## DEVELOPMENT APPLICATION ASSESSMENT REPORT

<b>Application Number:</b>	DA2024/1327
<b>Responsible Officer:</b>	Phil Lane
<b>Land to be developed (Address):</b>	Lot 401 DP 19651, 7 Pacific Road PALM BEACH NSW 2108
<b>Proposed Development:</b>	Alterations and additions to a dwelling house including secondary dwelling, garage and lift
<b>Zoning:</b>	C4 Environmental Living
<b>Development Permissible:</b>	Yes
<b>Existing Use Rights:</b>	No
<b>Consent Authority:</b>	Northern Beaches Council
<b>Land and Environment Court Action:</b>	No
<b>Applicant:</b>	Sean Clive Gartner
<b>Application Lodged:</b>	11/10/2024
<b>Integrated Development:</b>	No
<b>Designated Development:</b>	No
<b>State Reporting Category:</b>	Residential - Alterations and additions
<b>Notified:</b>	21/10/2024 to 04/11/2024
<b>Advertised:</b>	Not Advertised
<b>Submissions Received:</b>	3
<b>Clause 4.6 Variation:</b>	Nil
<b>Recommendation:</b>	Approval
<b>Estimated Cost of Works:</b>	\$ 517,000.00

**Figure 1: Area above 8.5m height plane highlighted in purple and calculation of slope under the building footprint**

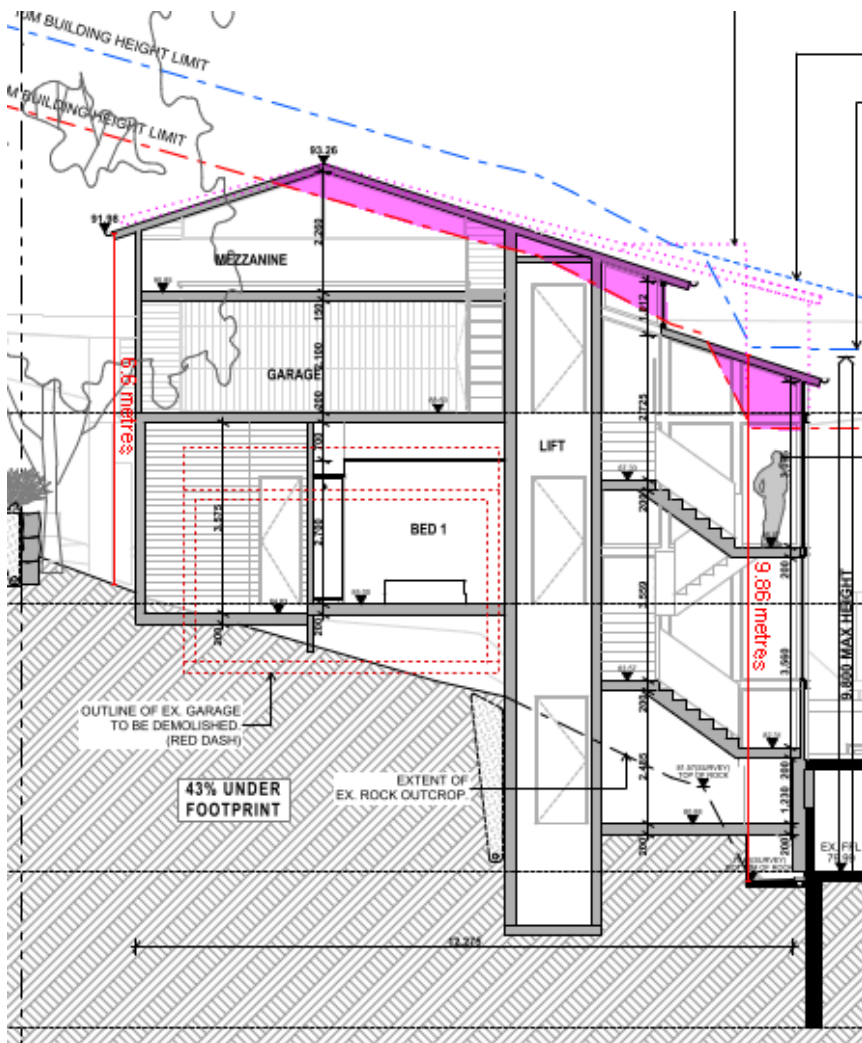
The areas of the stairwell and lift that protrude above the 8.5m height plane are confined to minor portions of the mezzanine of the garage, lift well for the lift and roof section of the stairwell. The breaches occur for a horizontal length of 7.7m and 2.1m (both on Section A). Figure 1 (Section A) below depicts the areas that protrude above the 8.5m height plane. These areas above the 8.5m height limit are considered minor given the low percentage (4.7%) these areas demonstrate overall versus the high percentage (95.3%) of the building demonstrates compliance with the 8.5m height control. The sections of roof which breaches the height limit is attributed to a section of roof associated with the mezzanine above the garage, the lift well and the roof within the stairwell as it extends down the site, where there is an abrupt change topography.
